工程指示 / 要求簡箋 ENGINEER INSTRUCTIONS(E.I.)

工程指示編號:	EI- 4546	修改版本:	-
	HK-		
工程編號:	J 858	工程名稱:	將軍澳日出康城11
收件人:	Maggie	發件人:	Eric Liu
工程項目:	地盤用 現場樣板玻璃(死牆)(1件單片)	日期:	06/04/2022

From: Andy Chan Yan Wai <andywchan@sino.com>
To: "jason.lcs.midi@gmail.com" <jason.lcs.midi@gmail.com>, Jun Leung Wai Tsui <Jun.Tsui@gammonconstruction.com>
Copies to: Herbert Thung <herbertthung@sino.com>, Francis Lai <francislai@sino.com>, Chan Pui Huen <chanpuihuen@sino.com>, Kenneth Leung <kennethleung@sino.com>, "TKOTL70 (Lohas Park Package 11)" <tkotl70@sino.com>
Subject: LP11 - Reflective Glass and Back Pan Mock Up
Date sent: Wed, 23 Mar 2022 03:30:48 +0000

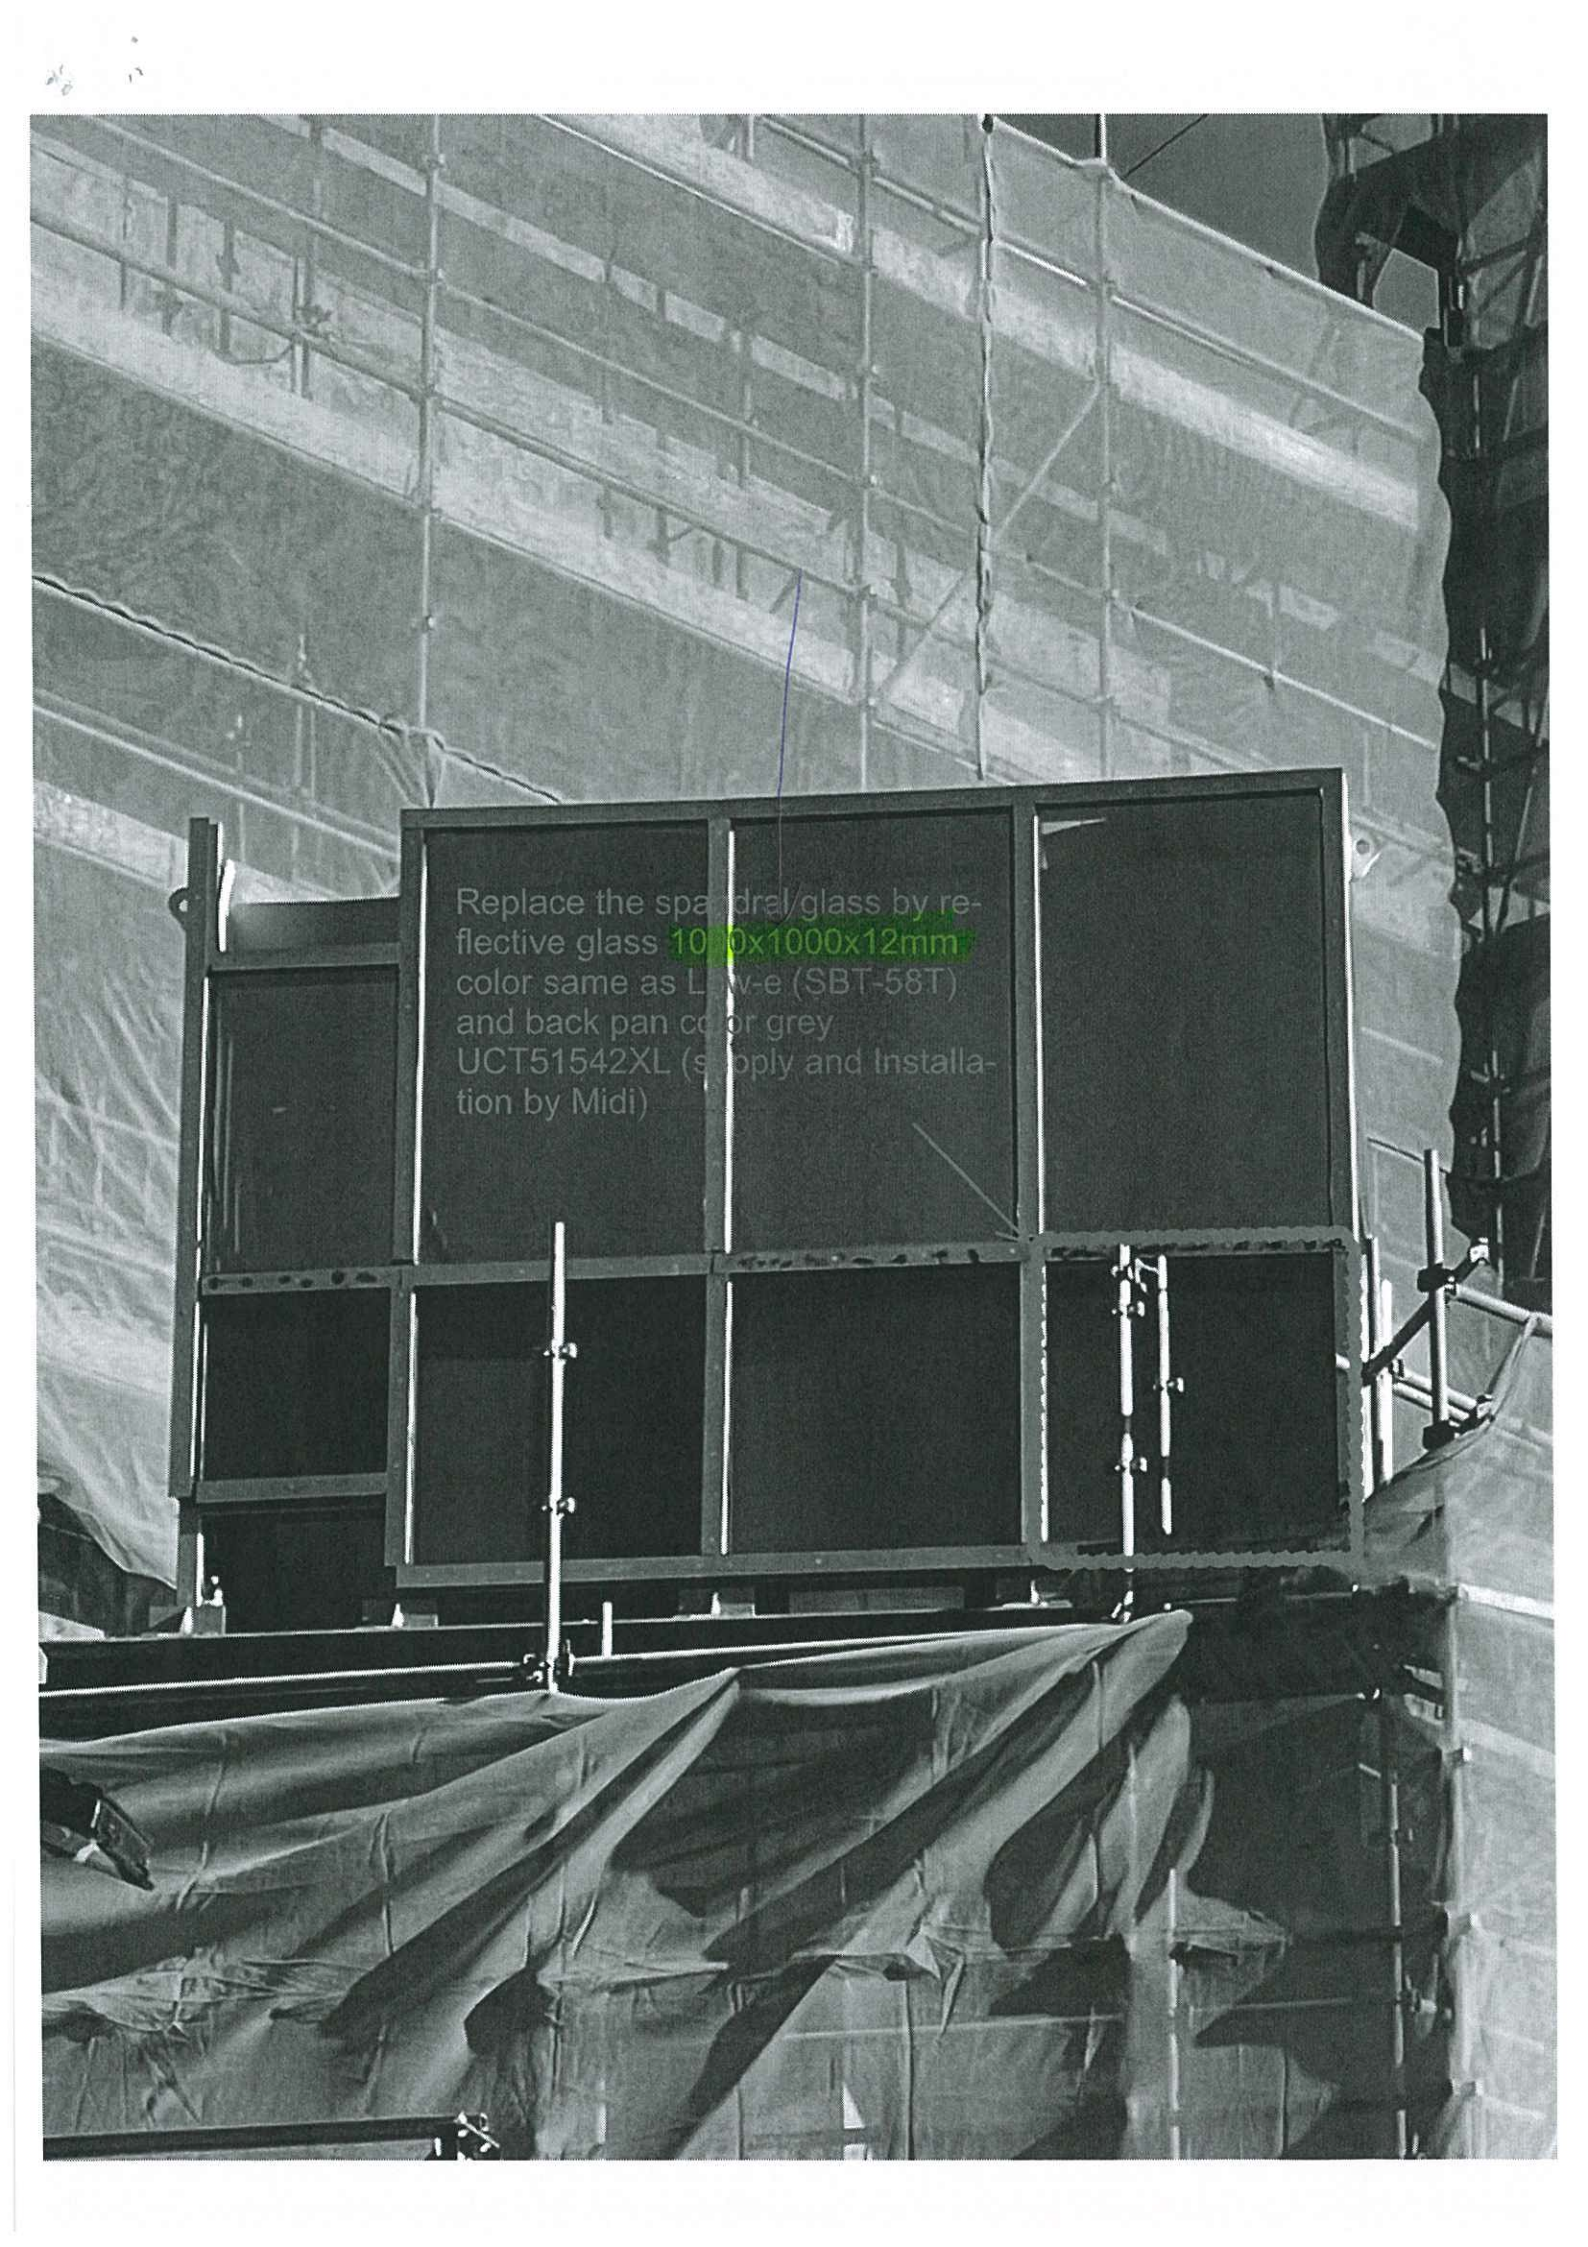
Replace the spandrel/glass by reflective glass 1000x1000x12mm color same as Low-e (SBT-58T) and back pan color grey UCT51542XL (supply and installation by Midi)
